Whitefish Water and Sewer Impact Fee Problems

Wastewater Collection Chart

Revised April 17, 2023

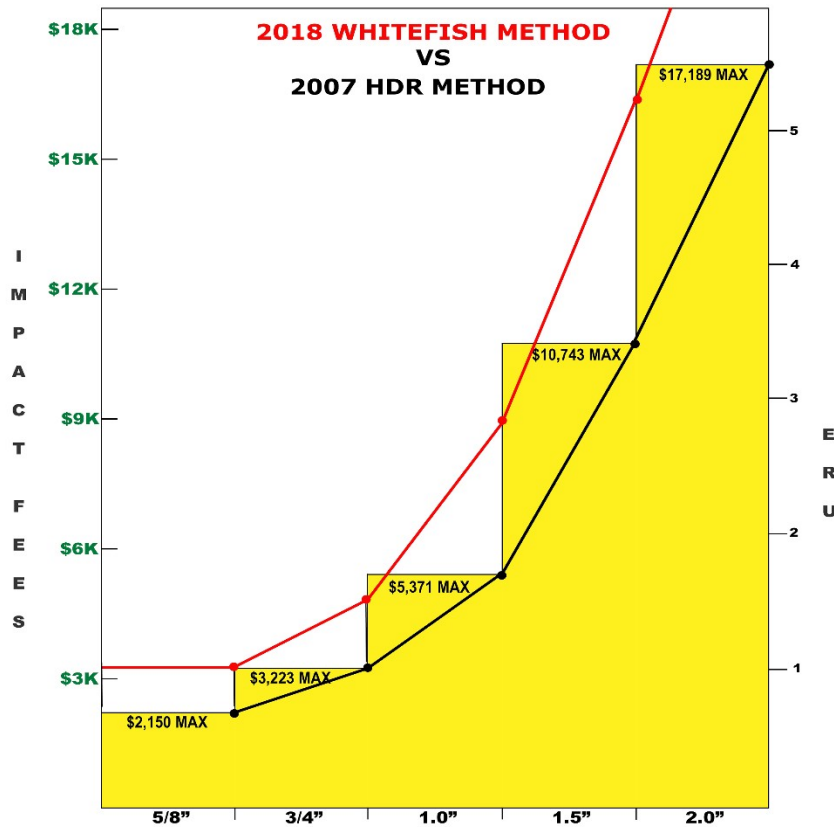
The following graphic demonstrates the difference between the HDR impact fee collection method and the method employed by Whitefish in the 2018 FCS update.

Note the Whitefish method (red dots) charges impact fees that start at or near the maximum allowable fee for the **Current** meter size. Fees increase to the maximum allowable fee for the next **Higher** meter size which exceeds allowable limits. The HDR method (black dots) charges impact fees that start at the maximum allowable fee for the **Prior** meter size and these fees increase up to the maximum allowable fee for the **Current** meter size. Although Whitefish claims it is following the HDR method, it clearly is not and is charging fees that exceed the maximum allowable for each meter size.

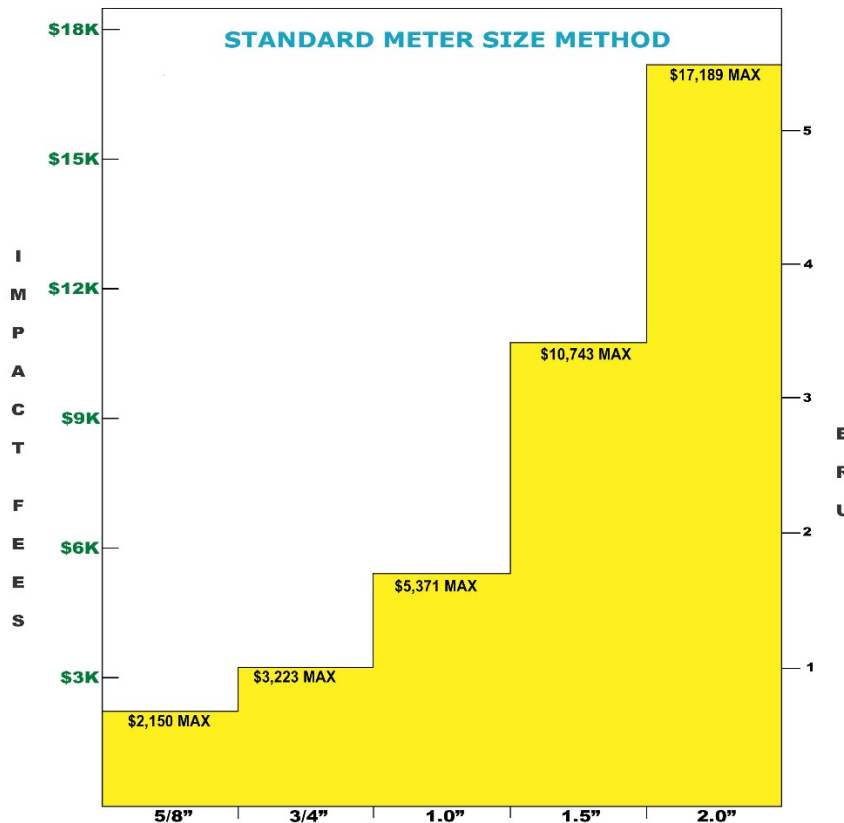
The following chart, using the FCS Update wastewater impact fee, demonstrates how most cities in Montana collect water and wastewater impact fees using a single fee per meter size.

Note the following:

1. Each meter size has only one fee charged starting at \$3223 for a 3/4" meter
2. Higher fees are charged for larger meters based on AWWA flow rates
3. No resident is charged more than the maximum fee per meter size.
4. Most cities in Montana use this method of impact fee collections.

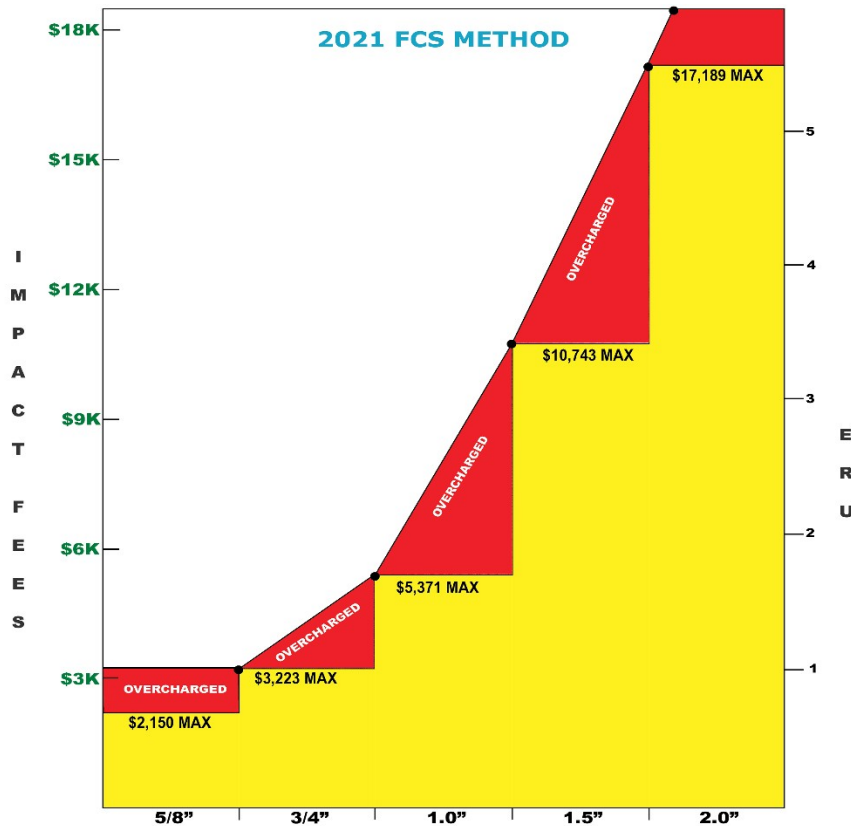
The overcharges are further shown in the below graphic to demonstrate the extent of the Whitefish wastewater impact fee problem:

Note the following:

1. The 2018 FCS Collection chart was built by Whitefish personnel, not FCS.
2. The chart was built on a 5/8" base meter size with incorrect current weighting factors associated with a 5/8" meter. The City does not install 5/8" meters.
3. Impact fee for each meter starts with **CURRENT** max allowable impact fee rather than the max fee associated with the **PRIOR** meter size, contrary to the HDR charts and description provided by Cil Pierce.
4. Most impact fees exceed the maximum allowable fee for that meter size.

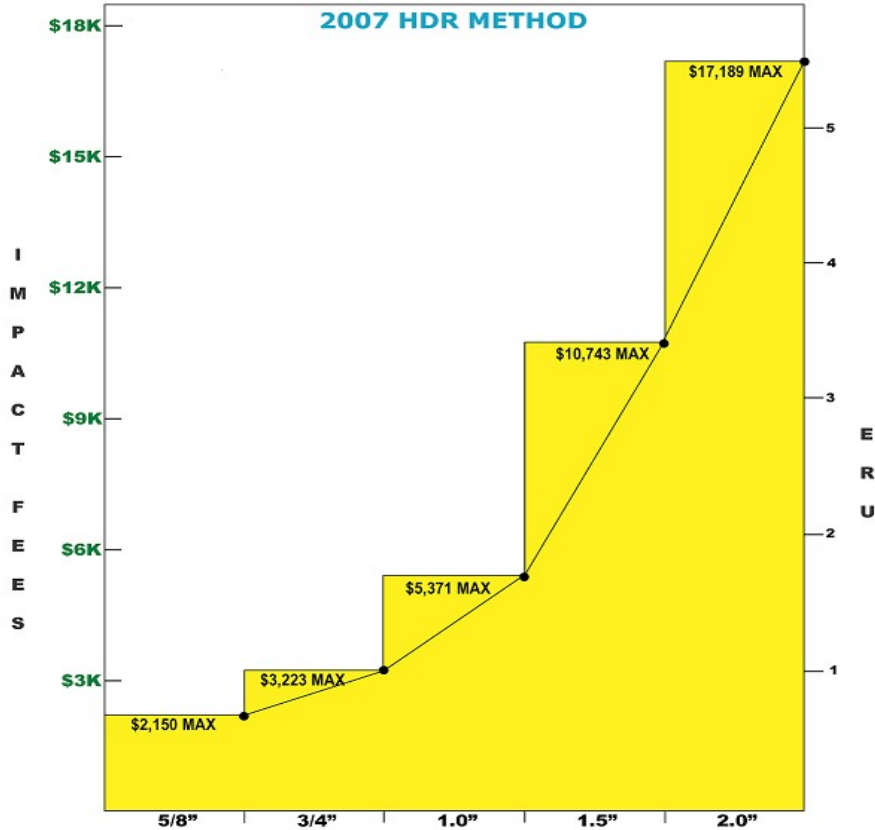
The following chart demonstrates how sewer impact fees should have been collected. This chart follows the exact design of the 2007 HDR Study.

Note the following:

1. Method follows exactly how Cil Pierce created the wastewater impact fee collection chart found in the 2007 Study and established by precedent in Whitefish .
2. Impact fees for each meter size start at the maximum allowable fee for the **PRIOR** meter.
3. Fees progress up to the maximum allowable fee for the **CURRENT** meter.
4. No fee exceeds the maximum allowable fee.
